Access Compliance Report

Public Rights-of-Way

(Curb Ramps)

Intersection ID: 46480	Main Street: REVENNA_LN	Cross Street: BERKELEY_PLACE_DR	Location: NW
ADA ID: 2800D5A9907D	Ramp Type: PerpDiag	Initial Pass/Fail: Fail	Overall Compliance: No
			Severity Score: 26.25

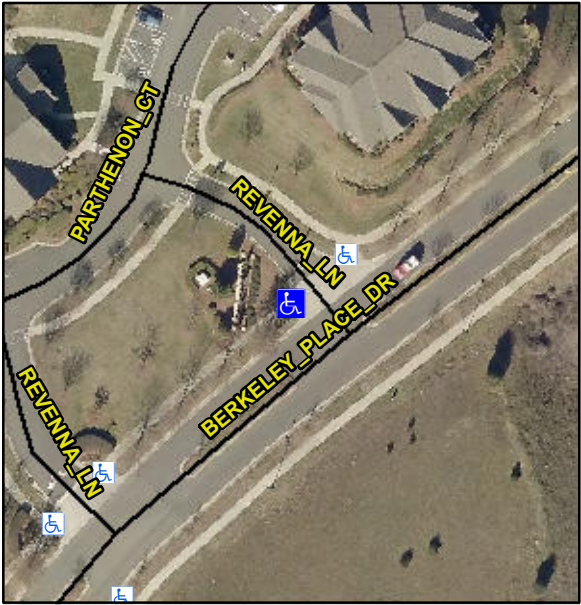
Codes/Mitigation Info/Possible Solution			Field Measurements/Component Compliance		
	Possible Solutions:		Compliance	Description	Data
	Remove & Replace Curb Ramp With Two New Directional Ramps or Equivalent.		N/A	Ramp Length (in)	63.0
			Yes	Ramp Width (in)	67.0
			N/A	Flare Type LT	N/A
			N/A	Flare Slope LT (%)	N/A
			N/A	Flare Traversable LT?	N/A
			N/A	Landing Length (in)	N/A
			N/A	Landing Width (in)	N/A
			N/A	Landing Slope (%)	N/A
			N/A	Landing X Slope (%)	N/A
<p>Surveyor Notes:</p> <p>N/A</p> <p>PROW/ADA:</p> <p>R304.2.2, R304.5.3</p>			N/A	Flare Type RT	N/A
			N/A	Flare Slope RT (%)	N/A
			N/A	Flare Traversable RT?	N/A
			N/A	DWS Provided?	N/A
			N/A	DWS Contrast?	N/A
			N/A	DWS Length (in)	N/A
			N/A	DWS Full Width?	N/A
			N/A	DWS Offset (in)	N/A
			N/A	Shared Landing?	N/A
			N/A	Gutter Ponding?	N/A
			N/A	Gutter Lip Ht (in)	N/A
			N/A	Painted X Walk1?	No
				X Walk 1 Direction	To E
			N/A	X Walk 1 Width (in)	N/A

X Walk 1 Slope (%)	2.8
				X Walk 1 X Slope (%)	3.1
			N/A	Ramp inside XWalk1?	N/A
				Road Slope (%)	5.1
				Road X Slope (%)	2.4
			N/A	Any Obstructions?	N/A
				Obstruction Type	
Total Cost:		\$ 3200.00			
			N/A		N/A
			Yes	Surface Condition? (G/P)	Good
